152 Royal College Street
London, NW1 0TA

Basement Impact Assessment
Audit

For
London Borough of Camden

Project Number: 12336-06
Revision: F1

Job Title 152 Royal College Street , NW1 0TA.				Job No. 15055
Drawing Title Section C-C, D-D & E-E				Drg. No. SK04
Scale @ A3 1:50	Date MARCH 2016	Drawn GM	Checked RD	Rev. -

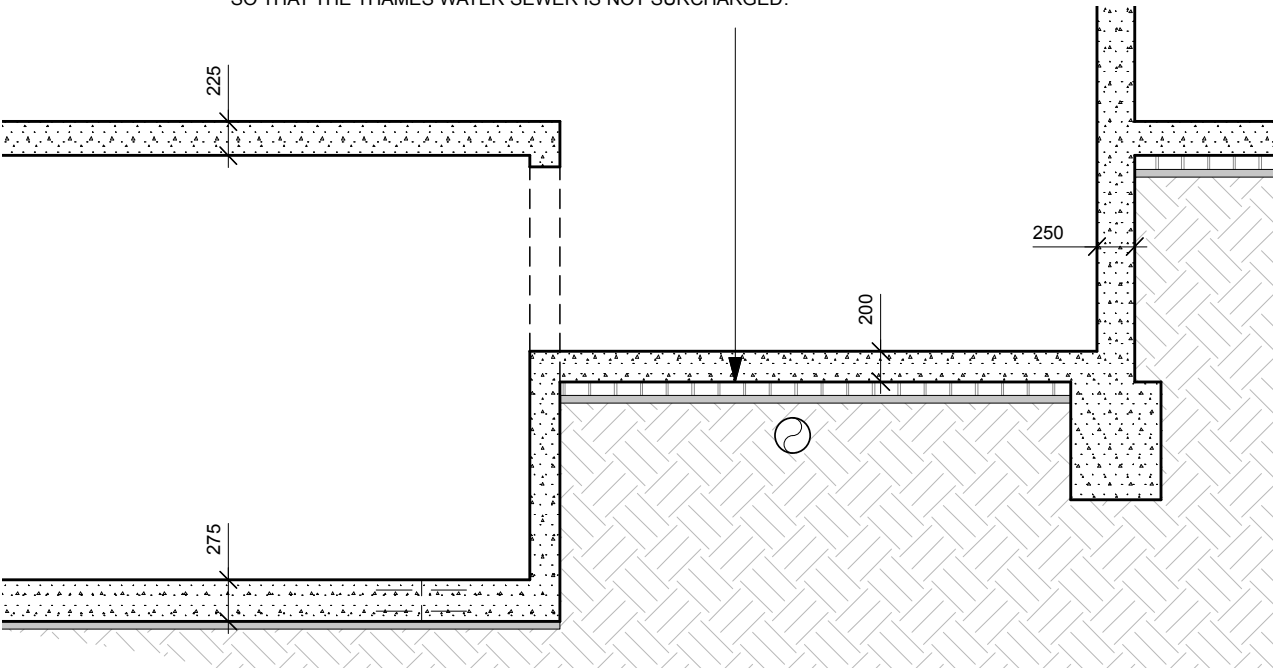
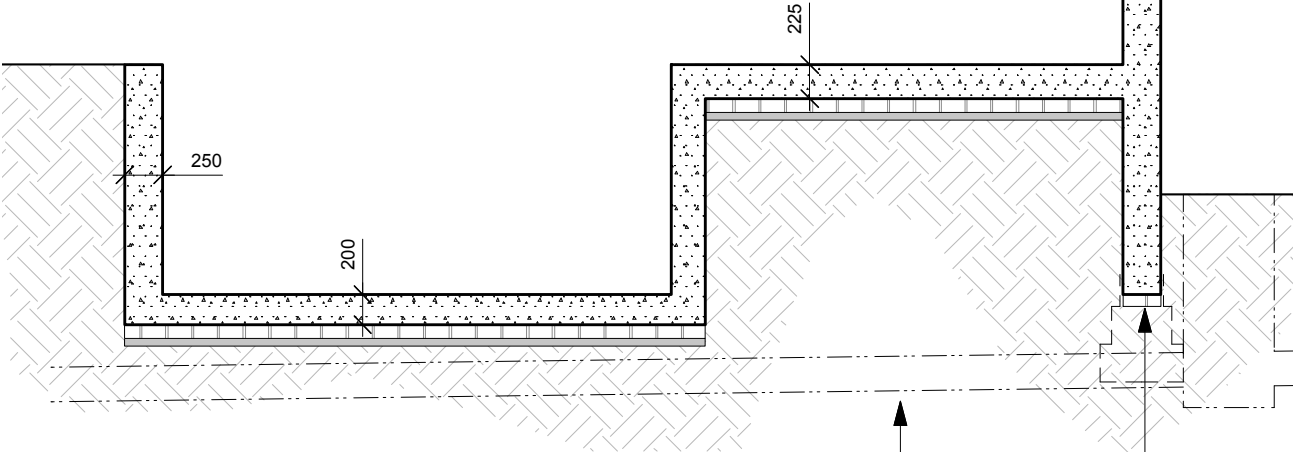
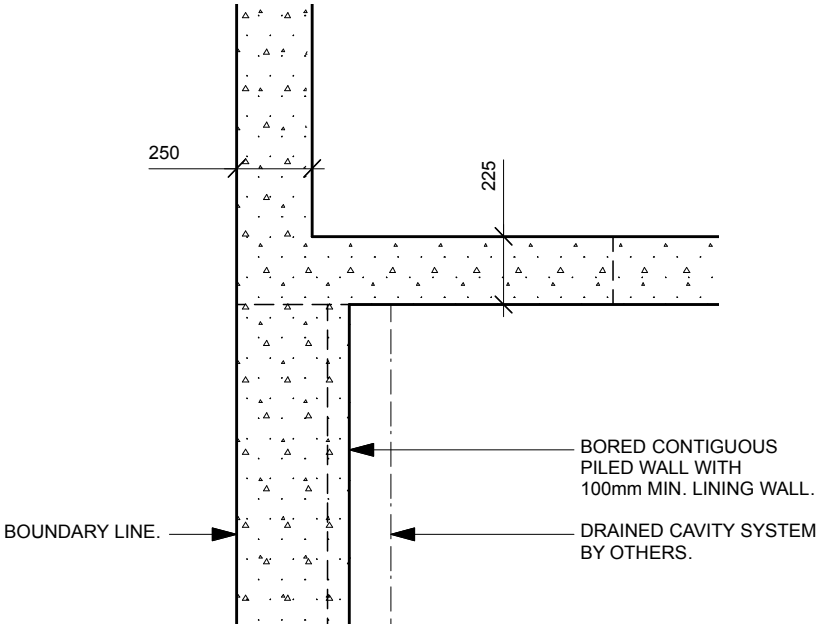
CORDEK CELLCORE VOID FORMER PROVIDED UNDER THE SLAB (DESIGNED AS SUSPENDED) & GROUND BEAMS SO THAT THE THAMES WATER SEWER IS NOT SURCHARGED.

Job Title 152 Royal College Street , NW1 0TA.				Job No. 15055
Drawing Title Basement GA				Drg. No. SK10
Scale @ A3 1:50	Date MARCH 2016	Drawn GM	Checked RD	Rev. -

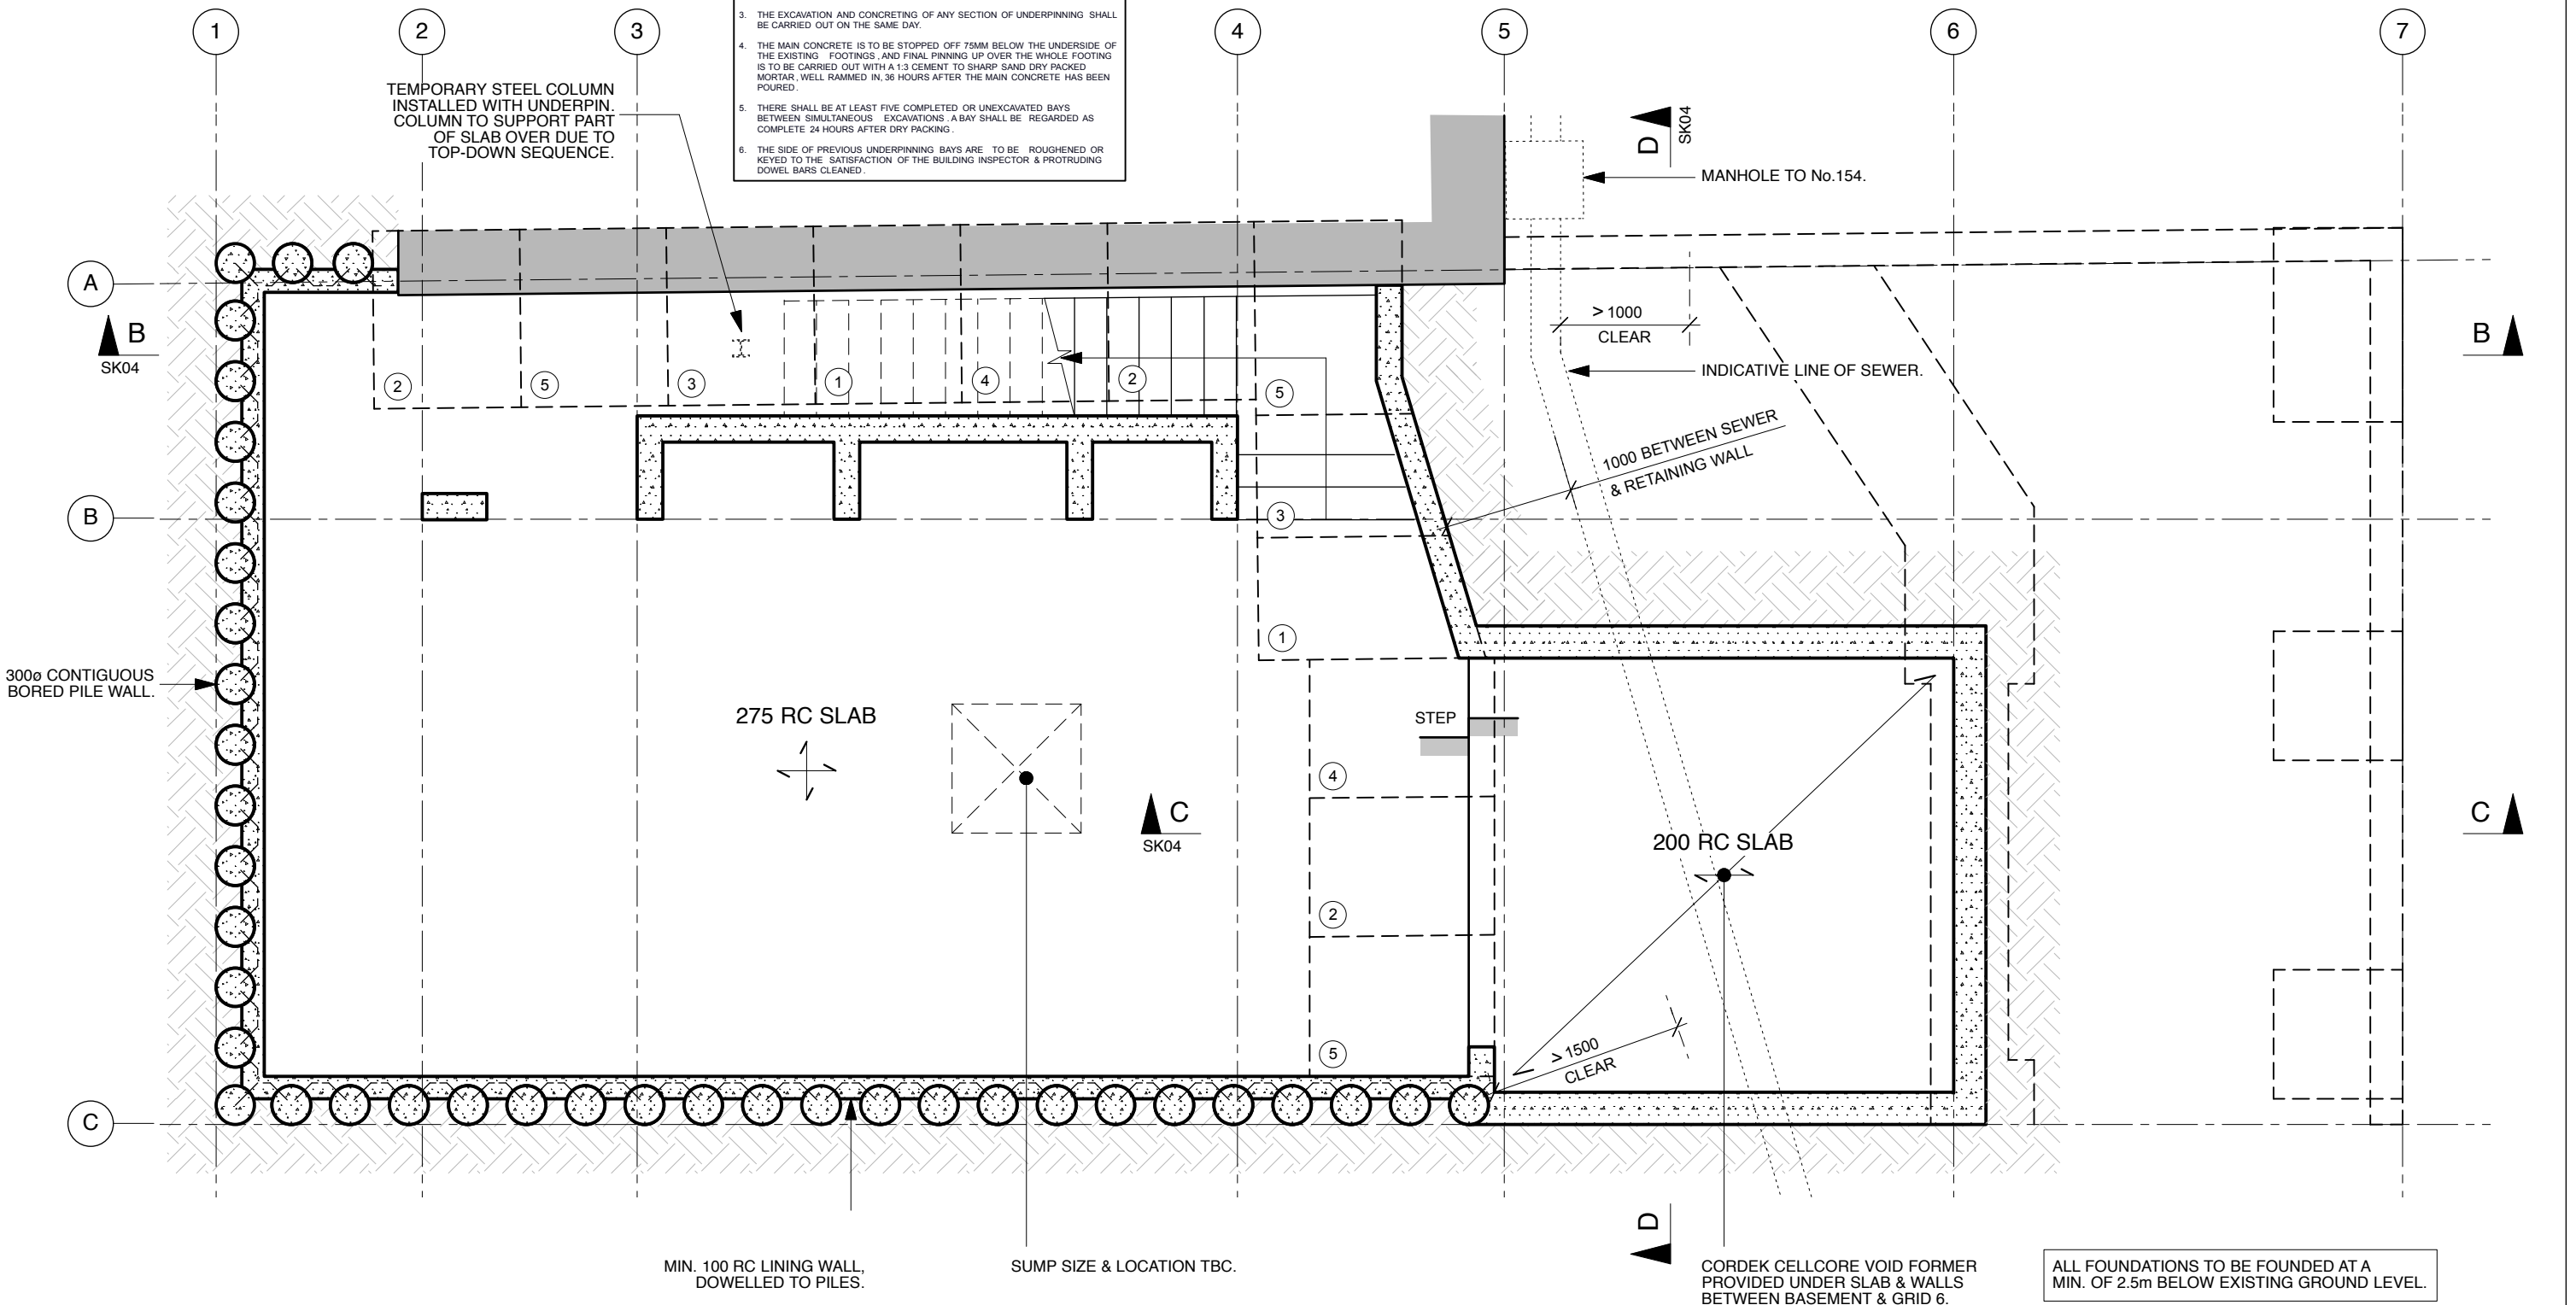
A contiguous pile wall is proposed along the Royal College Street and Baynes Street sides of the proposed reduced basement. Please refer to SK10 contained in Appendix A.
